30-039-06476 JICARILLA 110 #012

SRC requests approval to plug and abandon the Jicarilla 110 #12.
Attached are the Proposed Procedure, WBDs, Proposed Reclamation Plan, and Noxious Weed Form.

Re: Permanent Abandonment
Well: Jicarilla 110 12 API: 30-039-06476

CONDITIONS OF APPROVAL

PROPOSED P&A

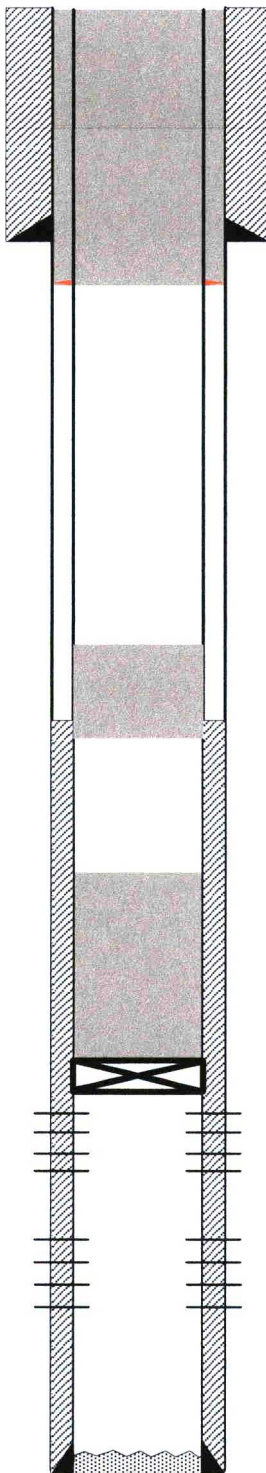
- Notify NMOCD 24hrs prior to beginning operations.
- Extend plug #1 to 3090'-2538' BLM Ojo Alamo pick @ 2588'.
- Adjust plug #2 to 1218'-1350' to cover the Nacimiento top. BLM Nacimiento pick @ 1268'. OCD Nacimiento pick @ 1300'.
